Errors in 2002 CWA Section 303(d) List of Water Quality Limited Segments (October 15, 2002)

Response to Comments

Calleguas Creek Watershed

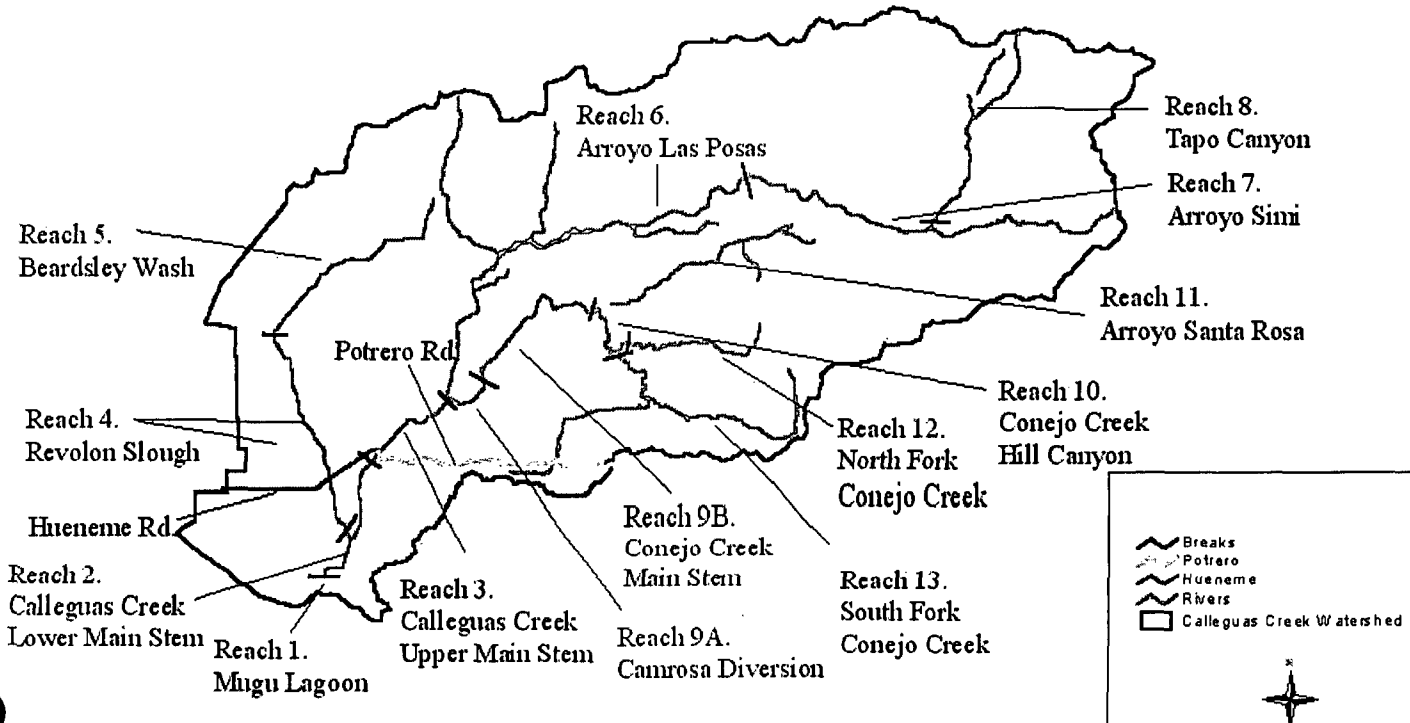
Here is a map of the old and new 303(d) reaches. The old reaches consisted of two different reaches, reach 1 was below Potrero Rd. and Reach 2 was above Potrero Rd. The new reaches are delineated and labled on the map. I have attached the map in JPEG format for you.
